memorandum

re: Geotechnical Review of Grading Plans

Proposed Residential Development - Trails Edge - Stage 3

date: November 10, 2025 file: PG2392-MEMO.02

EPS BLOCK INSTALLATION AROUND RESIDENTIAL BUILDINGS

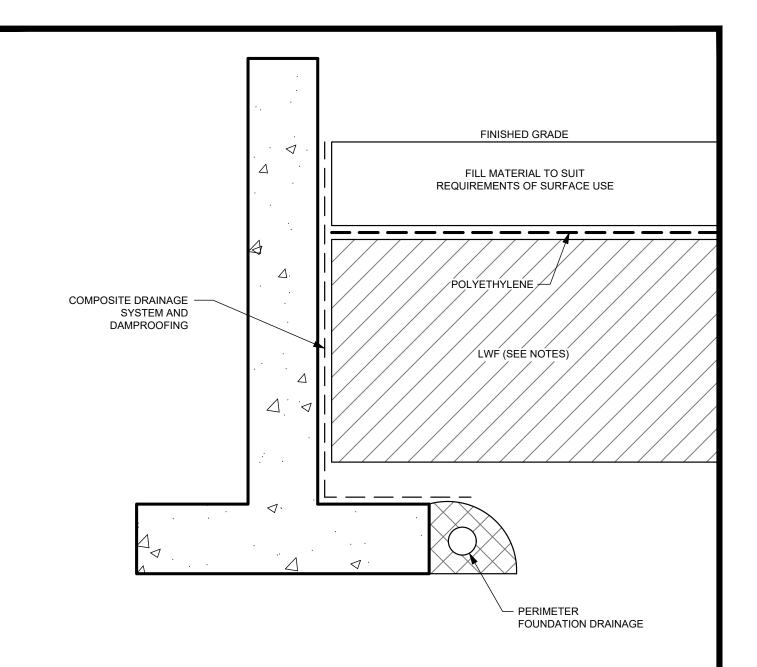
Based on our review of the above-noted drawing, a number of blocks/units of the subject site exceeded our permissible grade raise recommendations provided in the above-noted geotechnical report. Where significant grade raise exceedences have occurred, lightweight fill (LWF), such as expanded polystyrene (EPS) geofoam blocks are recommended for specific areas adjacent to the subject buildings. It should be noted that the proposed roadway grades throughout the subject site were found to be within the recommended permissible grade raise restrictions for roadways provided in the aforementioned geotechnical investigation report. Further, sufficient soil cover has been provided to perimeter and exterior pad footings to mitigate the migration of frost within the founding subsoils.

- 1. USE EPS12 BELOW FRONT PORCH AND LANDSCAPED AREAS
- 2. USE EPS15 BELOW GARAGE AND DRIVEWAY
- MINIMUM GRANULAR THICKNESS OVER LWF SHOULD BE AS FOLLOWS:

FRONT PORCH 150mm OF OPSS GRANULAR A
GARAGE 300mm OF OPSS GRANULAR A
DRIVEWAY 450mm OF OPSS GRANULAR A
LANDSCAPED 500mm OF APPROVED BACKFILL SOIL

PLACEMENT OF LWF SHOULD BE ON A LEVELED SURFACE (SAND CAN BE USED TO PROVIDE AN ADEQUATE LEVELLING SURFACE).
